ADDENDUM NUMBER: ONE (1)

DATE: May 2, 2024

PROJECT: ATHLETIC COMPLEX AT STOKES FIELD
COMMUNITY CENTER RENOVATION

DESIGNER: MONTGOMERY COUNTY ENGINEERING

5
A1.4 DETAIL
BUILDING 1 SCALE 3"=1'-0"

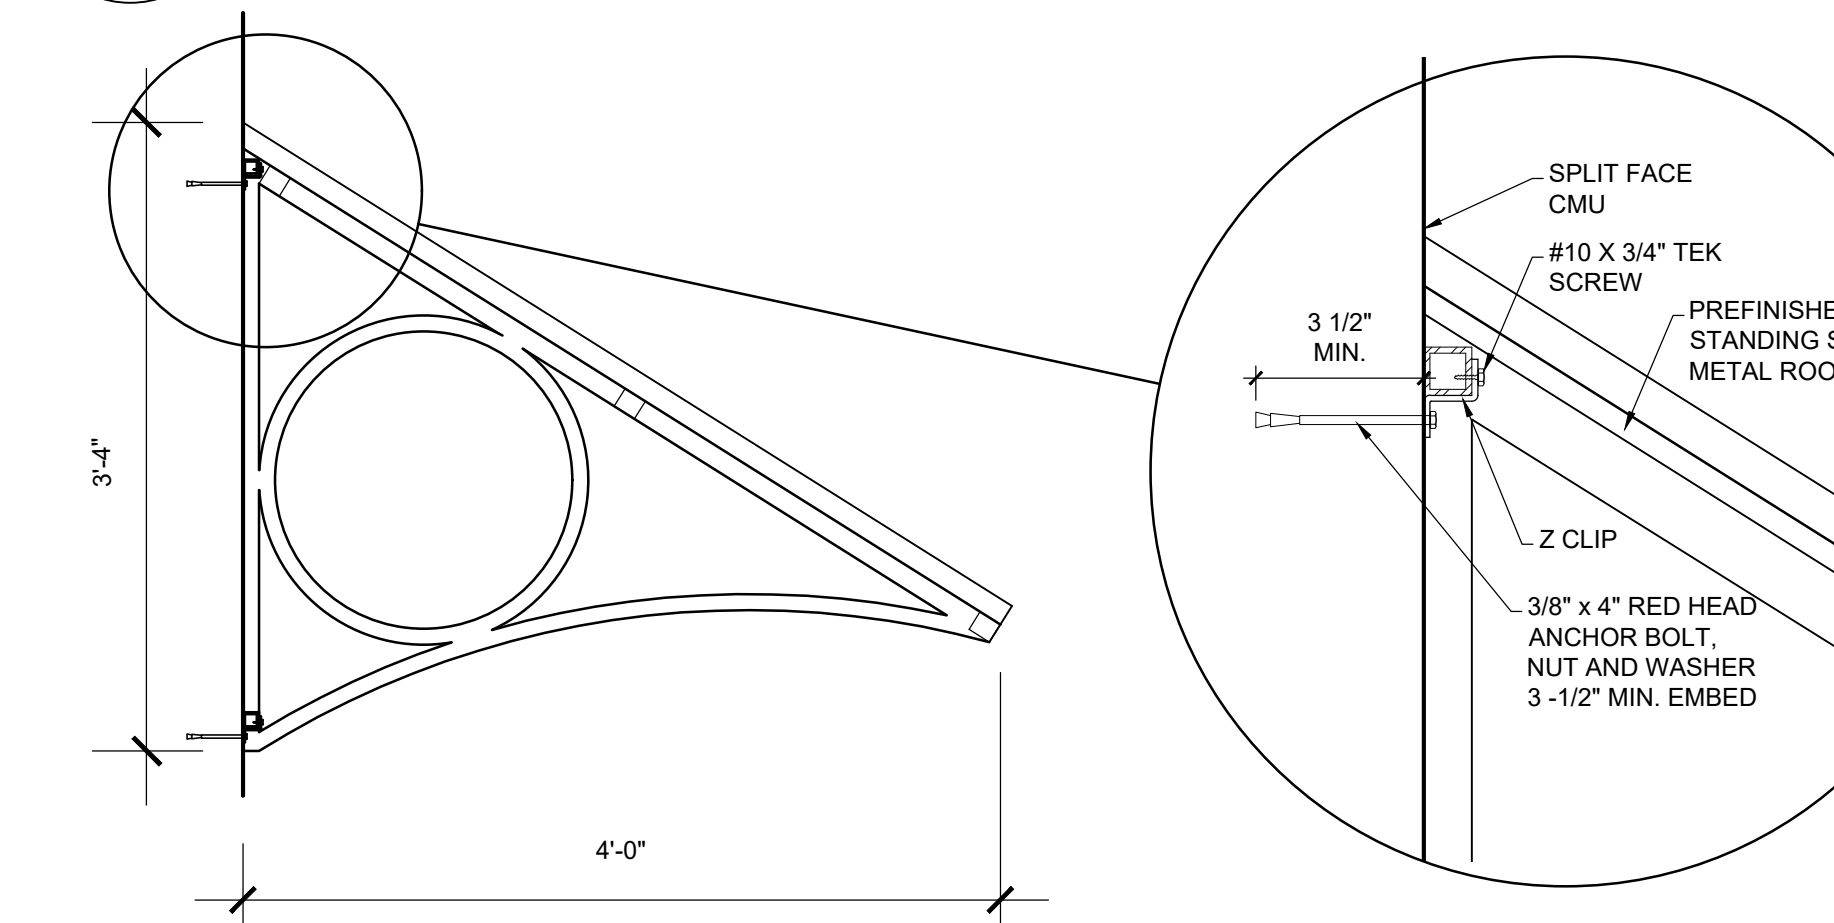
3. Drawing Sheet A1.4: Drawing A1.4 is revised and dated 4-30-2024 and replaces the original A1.4. Notes to a section detail calling out the soffit material has been revised to call out Pre-finished Corrugated Metal Soffit Material.

- Q.** Does metal ceiling of cooking pavilion attach to wood 2x10 purlins?
A. See revised sheet A1.4 and specification section 074110 for new details.
- Q.** Plan A3.0 Detail 1 shows spigot in Northeast corner of building, note says see plumbing drawing but there is no plumbing drawing for this building.?

MONTGOMERY COUNTY
TENNESSEE
ATHLETIC COMPLEX AT STOKES FIELD
OVERALL ELECTRICAL LIGHTING SITE PLAN

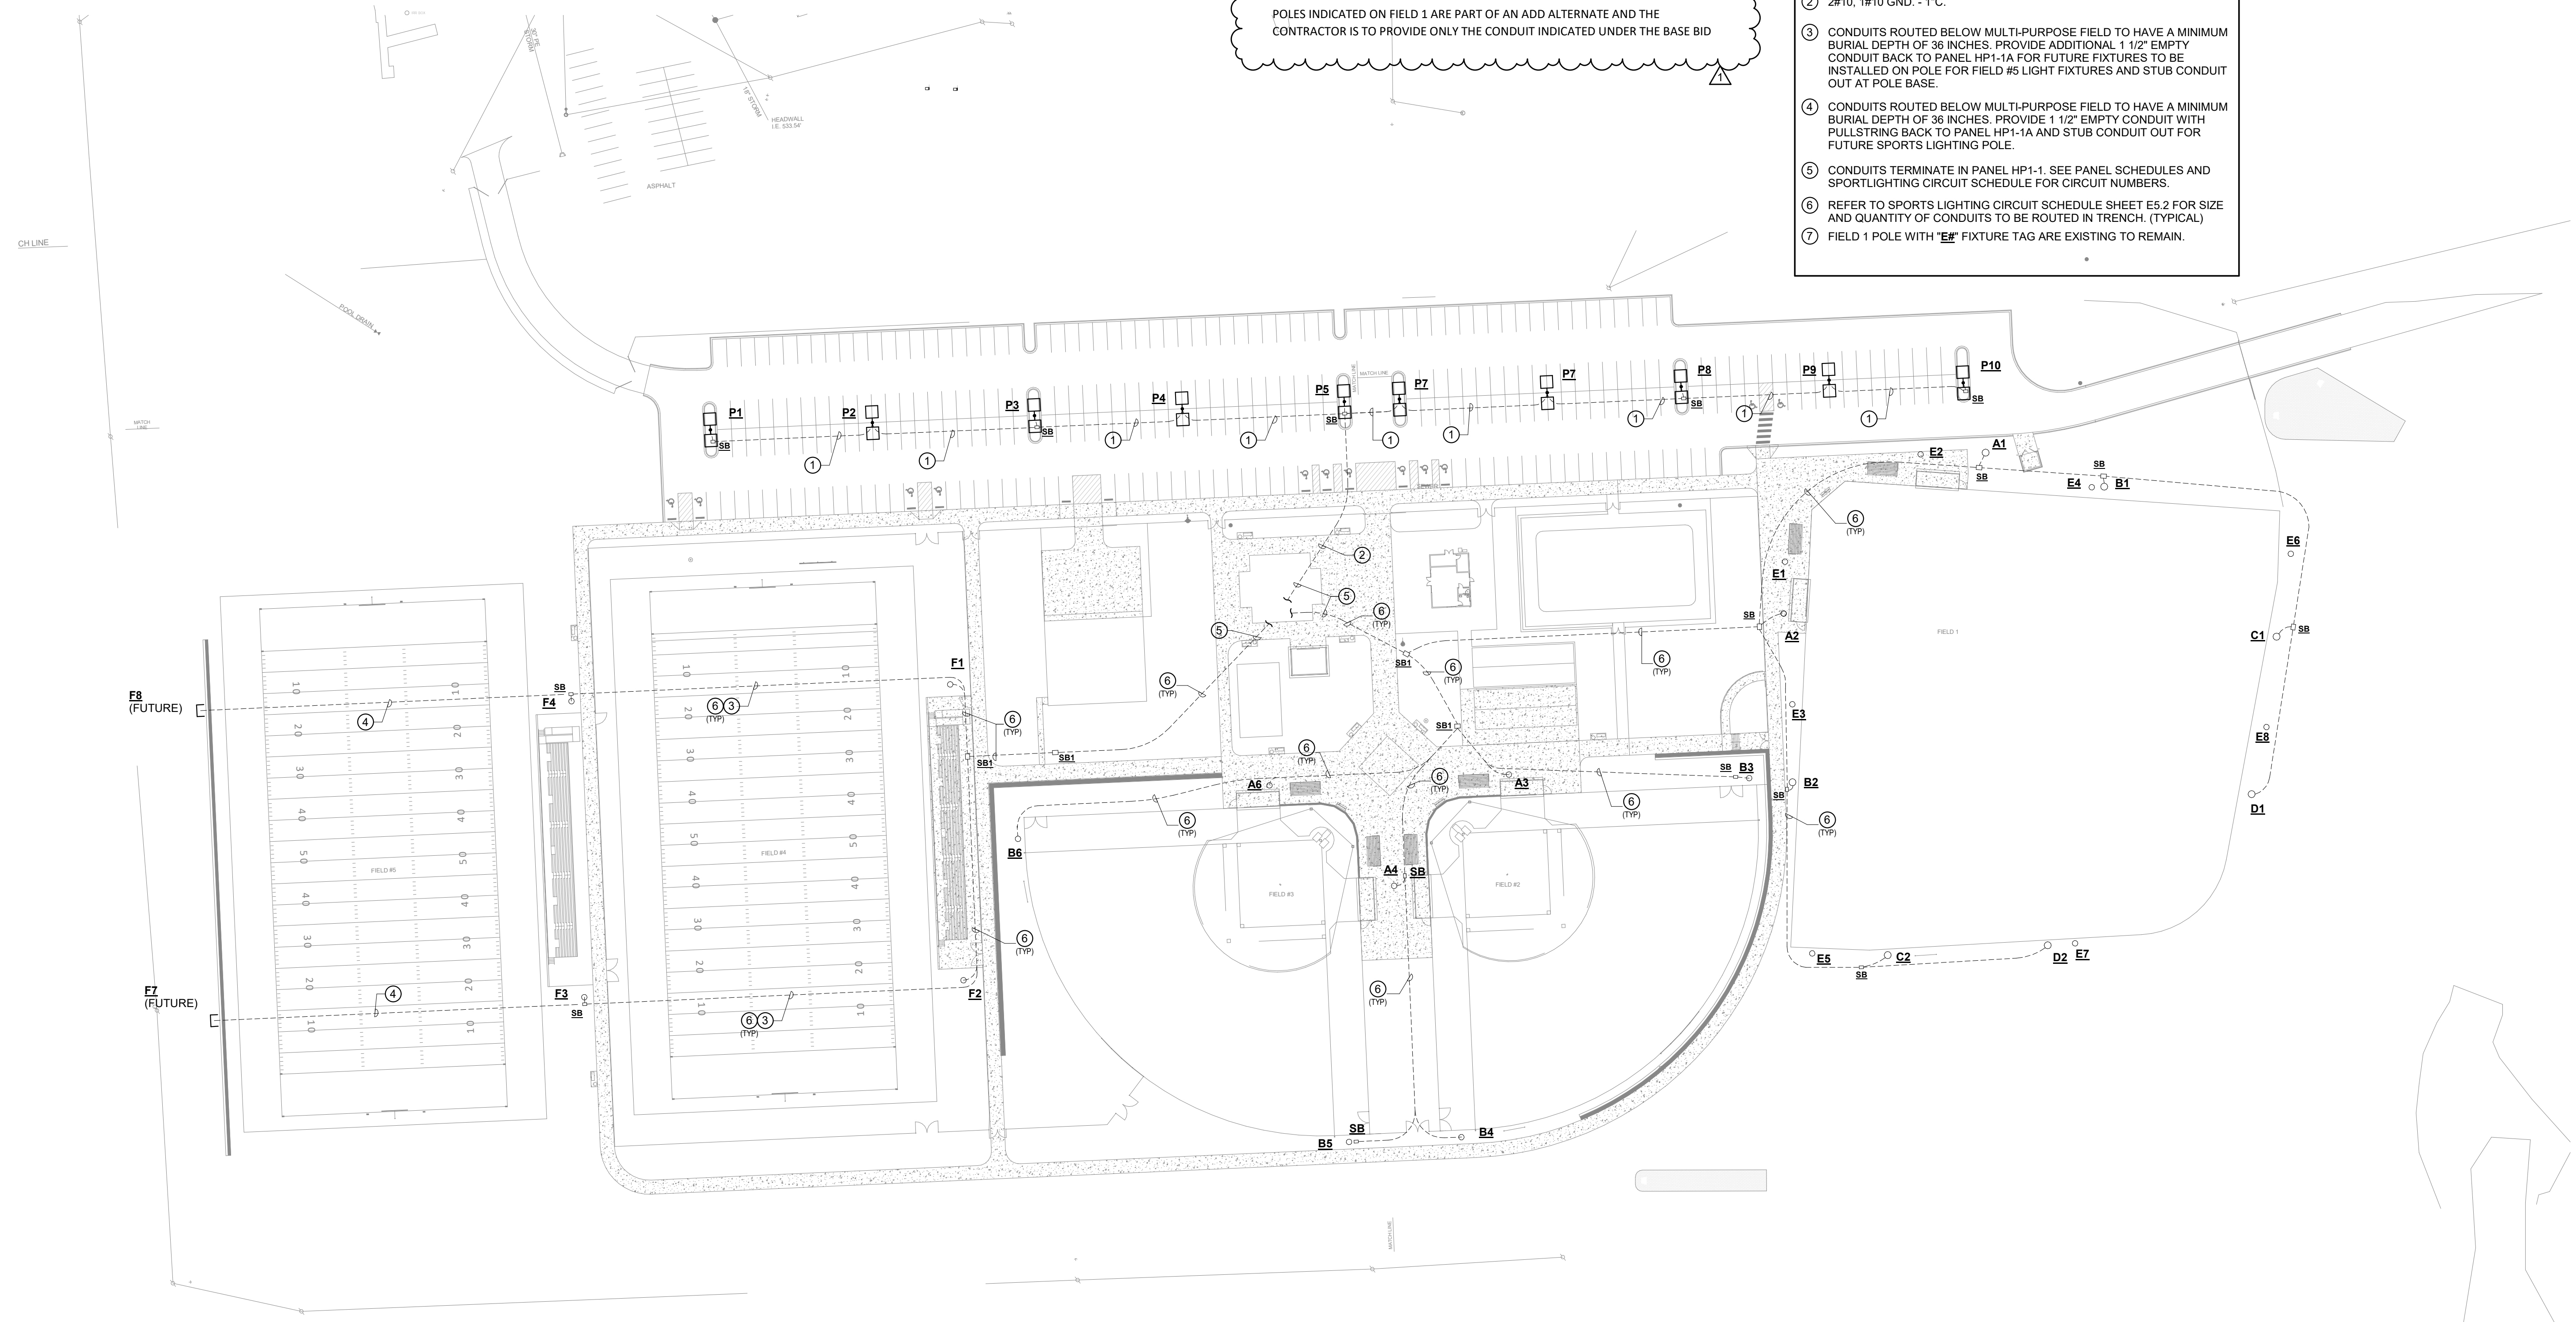
4. Drawing Sheet ES1.1: Drawing ES1.1 is revised and dated 4-30-24 and replaces the original ES1.1. The "Sports Lighting Pole Conductor Schedule" was moved from Sheet E5.2 to Sheet ES1.1.
